THE CITY OF DURHAM TRUST

DM/25/03404/OUT – Integra 61 Phase 2 to the west of Amazon UK Integra 61, West Bowburn, DH6 5FG

Outline planning application for the erection of commercial buildings (B2 (General Industrial), B8 (Storage and Distribution)) with ancillary office floorspace, part new road linking the A688 to the A177 with associated infrastructure, access, landscaping and other related works (all matters reserved)

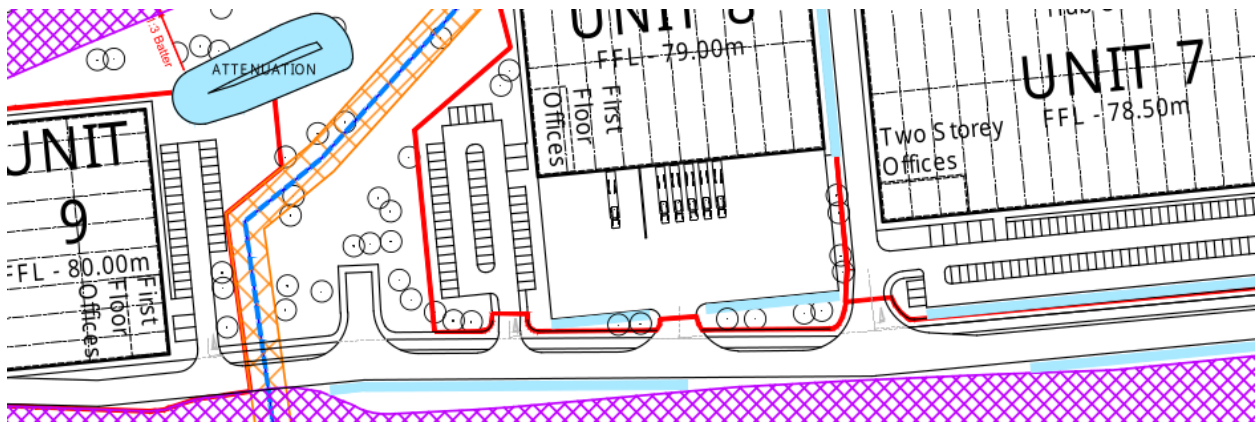
The documentation mentions the possibility of a “halt” on the Leamside Line to serve the area (Transport scoping note, para. 1.3.3, Appendices to Chapter E PDF p. 93). The Trust would like to see assurances that there will be sufficient land remaining alongside the Leamside Line to provide the optimum location for a future Bowburn railway station, and that suitable pedestrian and vehicular access will be achievable.

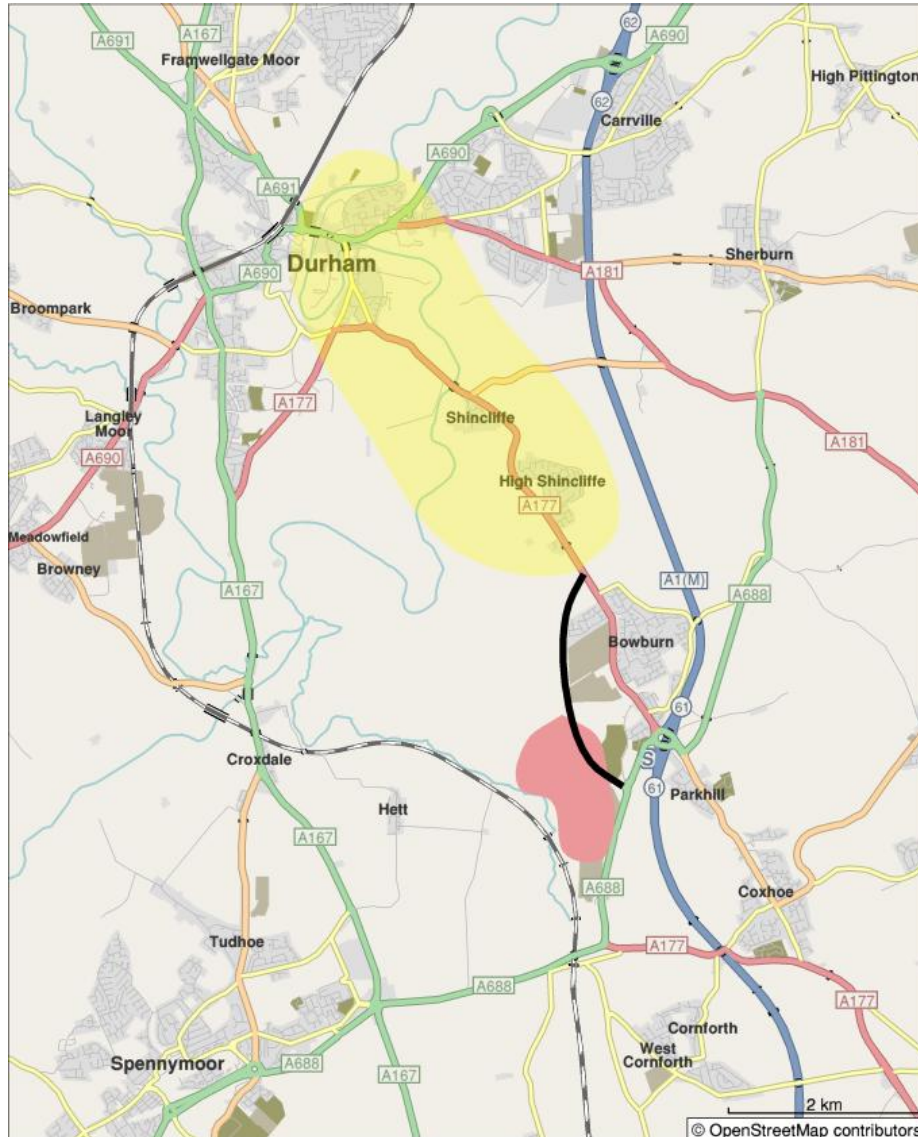
It is now possible to test that claim using the Department for Transport's Connectivity Tool Lite (see <https://connectivity-tool-lite.dft.gov.uk/>). Setting the transport mode to “overall, except driving”, and the destination type to “workplaces”, the area occupied by Integra 61 and the proposed Phase 2 score in the range 42 to 50, which fall between the 10th and 30th percentile. This means that more than seven out of ten workplaces in England are better connected in terms of sustainable transport. The Connectivity Tool does not take into account the *quality* of cycle routes, therefore this assessment may be overly favourable.

The building of the Bowburn Relief Road will improve the connectivity score, but it seems unlikely to push it any higher than the A177 through Bowburn village which sits at around the 40th percentile. By contrast, Durham city centre scores at around the 70th percentile.

Even when considering the score for overall driving connectivity, the site currently sits between the 30th and the 45th percentile, compared with the 75th percentile for Durham city, but the difference in actual score is rather less. This reflects how much more accessible the site is by car, and how challenging it will be to attain significant shift to sustainable modes. It is doubtful that the site can be described as highly sustainable. In fact, it appears to be firmly below the median for England in terms of all forms of connectivity.

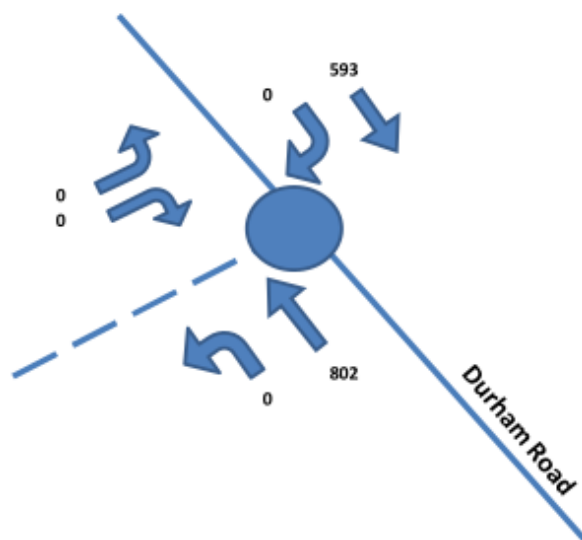
The following map shows the approximate area of the Integra61 site in pink, and the route of the new road in black. Traffic heading north on this road will continue northwards on the A177 through High Shincliffe and Shincliffe. Some of the traffic may be seeking destinations in those two villages, or in the Elvet area of Durham City. The area shaded pale yellow seeks to indicate the parts of Durham City which

it would be desirable to access via the A177.

For access to Gilesgate or Carrville, the A1(M) or A688/A181 could be used to avoid Durham city centre and the Air Quality Management Area.

Neville's Cross, Framwellgate Moor and other areas north of the city centre could be reached via the A688 to the Thinford roundabout and the A167. Online journey planners suggest that this longer route would only add two minutes to the journey time when traffic is free-flowing.

The challenge will be how to ensure that traffic is encouraged to use the major roads, and avoid the shorter routes through Coxhoe, Bowburn, Shincliffe and Durham city centre. The Trust notes that in the
